**Metro Manila Subway Project Phase 1  
PACKAGE CP104: (ORTIGAS NORTH AND ORTIGAS SOUTH)**

ITEM NO.	REFERENCE/CLAUSE/SECTION	QUERIES	RESPONSE
----------	--------------------------	---------	----------

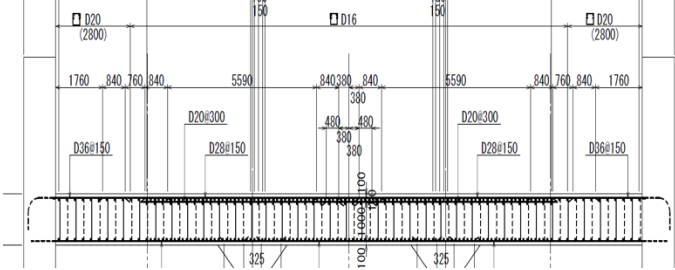
85.	Fences at OS Station Plaza DWG No. SPL-C-SP-OS-1012 and 1013 indicate the lines in blue color are FENCE TYPE-1. However, no details on FENCE TYPE-1 are available in DWG No. SPL-C-SP-OS-1015, instead FENCE TYPE-2 is shown. For your information, the lines in	Please make correction appropriately on the said drawings at the OS Station Plaza.	OS station plaza drawings have been revised for consistency and Fence Type 1 detail to be shown. Please refer the revised drawings SPL-C-SP-OS-1012 and 1013 in Annex C of this GBB.

ITEM NO.	REFERENCE/CLAUSE/SECTION	QUERIES	RESPONSE
	blue color are TYPE-2 in the drawings of ON station plaza.		
86.	TN-CE-PIT-0007 and 0008	The drawing numbers TN-CE-PIT-0007 and 0008 Show the intermediate pit support consisting of shotcrete lining with wire mesh and lattice girders as temporary works for reference only. However, the drawing numbers TN-CE-PIT-0005 and 0006 indicating the tunnel permanent RC lining also contain the shotcrete lining as the contract drawings. Please advise if the shotcrete lining is a temporary support only during excavation or a part of permanent support. Should the shotcrete lining be a part of the permanent support, please also confirm who is responsible for design of the shotcrete lining.	The shotcrete lining is temporary works. Therefore, The Contractor is responsible for the shotcrete lining.

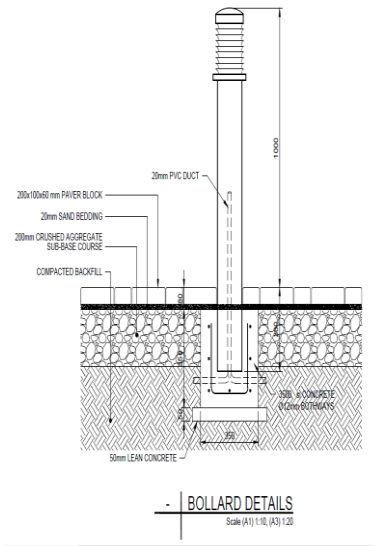
87.	TN-CE-PIT-0004	Whilst the drawing number TN-CE-PIT-0004 shows the temporary support ring for construction of the intermediate pit, this drawing is not labeled as "Reference only" or "Temporary works". Please clarify and advise if the details indicated on this drawing should be adopted as the Contract requirement or the contractor should develop own details of the temporary	The Contractor shall develop own details of temporary support.

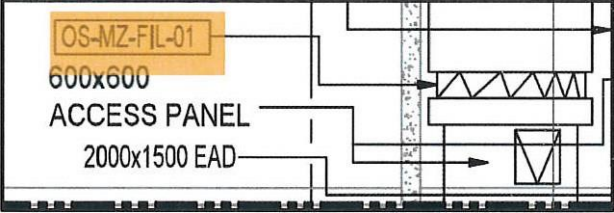
ITEM NO.	REFERENCE/CLAUSE/SECTION	QUERIES	RESPONSE
90.	STN-CE-OS-0035 onwards	<p>Based on the bid drawings provided. We noticed that there are no details of stirrups/ ties for slab and end walls. We would like to request detailed drawings of square bars on slabs and end walls.</p> 	Please refer to drawing STN-CE-OS-0035.
91.	BOQ 727 Metal Bollard	<p>a. The pay item and description on the BOQ is 603-A Bollards, is this the same to 727 Metal bollards on the specifications?</p> <p>b. Please clarify if the material on the said pay item is metal/stainless steel? There are also no detail or type of material indicated on the drawing from SPL-C-RD-ON-1034. We request a more detailed drawing of this Pay item.</p>	<p>a. Yes, those are the same.</p> <p>b Yes, it is metal/stainless steel. No further information will be provided as it is not necessary for bidding.</p>

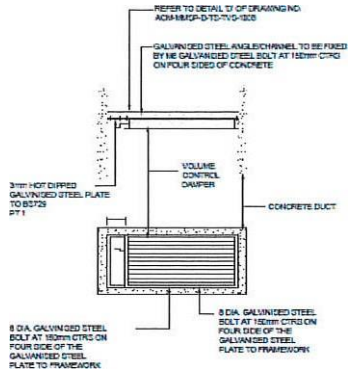
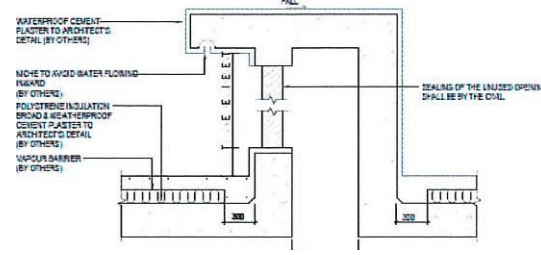
92.	STN-AR-A-ON-0600	Architectural Drawing STN-AR-A-ON-0600 shows Smoke Proof areas at the Concourse Level bounded by smoke screens. Kindly provide details, specifications and sequence of operation of smoke screens.	Bidders to refer to standard details and Technical Specification 2: Architecture.
93.	SPL-C-RD-ON-1031 SPL-C-RD-OS-1032	As we review the bid drawings, we noticed that curb & gutter has no rebar details. May we request for the rebar details.	No further information will be provided as it is not necessary for bidding.
94.	SPL-C-DR-ON-1052 SPL-C-DR-ON-1053	As we review the bid drawings, we noticed that there is no waterproofing and polyethylene sheet applied on	Items are included in unit rate of manholes in BOQ.

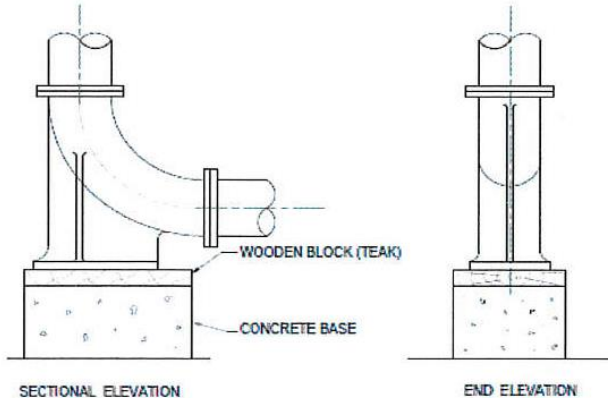
ITEM NO.	REFERENCE/CLAUSE/SECTION	QUERIES	RESPONSE
		 <p>Items reflected on plans but not seen on Equipment Schedule &amp; BOQ</p>	
98.	SPL-C-SP-ON-1012 SPL-C-SP-ON-1013 SPL-C-SP-OS-1012 SPL-C-SP-OS-1013	As we review the drawings, we noticed that the legend used for identification of fence type in Ortigas North Station Plaza is different from Ortigas South Station Plaza. Please clarify which legend will be used.	These have been made consistent Type 1- Magenta CHB Wall Type 2 – Blue Cyclone Fence
99.	STN-MEP-VAC-CWD-1109	Please provide dimensions for Concrete Duct for Volume Control Damper. Please see drawing below:	No further information will be provided as it is not necessary for bidding.

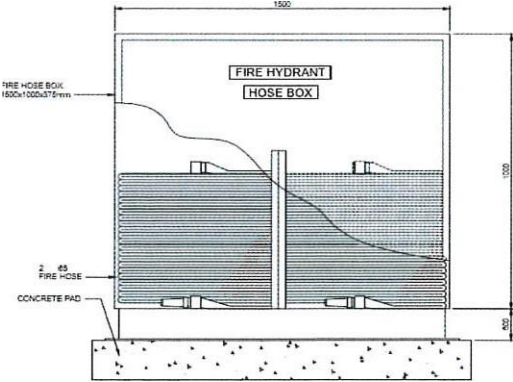
ITEM NO.	REFERENCE/CLAUSE/SECTION	QUERIES	RESPONSE
105.	STN-MEP-PLD-ON-3112 STN-MEP-PLD-ON-3113 STN-MEP-PLD-ON-3122 STN-MEP-PLD-ON-3134 STN-MEP-PLD-OS-3111 STN-MEP-PLD-OS-3113 STN-MEP-PLD-OS-3114	Kindly provide details for ceiling access panels on the following plans.	No further information will be provided as it is not necessary for bidding.
106.	STN-MEP-FPS-CWD-1202	Kindly indicate the location of the Duct Foot Bend in the plans. Please see drawing below for the detail:   <p style="text-align: center;">SECTIONAL ELEVATION                      END ELEVATION</p> <p style="text-align: center;"><b>2.07   DUCK FOOT BEND</b> Scale: NTS</p>	No further information will be provided as it is not necessary for bidding.

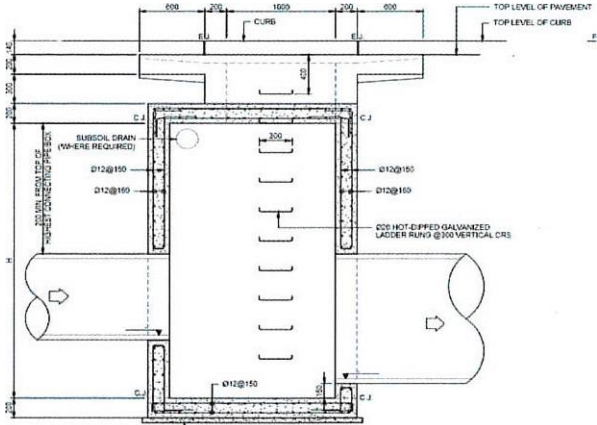
111.	TS2 Arch p235 1012.2.1 1) e) DWG	Please confirm if 2.25m height is only for security film. If not, please revise the drawing accordingly.	Description of GL-05 in finishing schedule "12 mm thick toughened glass with frosted film" to be updated to "12 mm thick toughened glass with design film". Please refer

ITEM NO.	REFERENCE/CLAUSE/SECTION	QUERIES	RESPONSE
	Glass Partition at Concourse Level DWG Nos. STN-AR-A-ON/OS-9250 indicate that height of glass partition at concourse is 3200mm. On the other hand, the specifications state GL-05 12 mm thick toughened glass with custom-designed security film at 2.25m height"		to Annex B of this GBB.
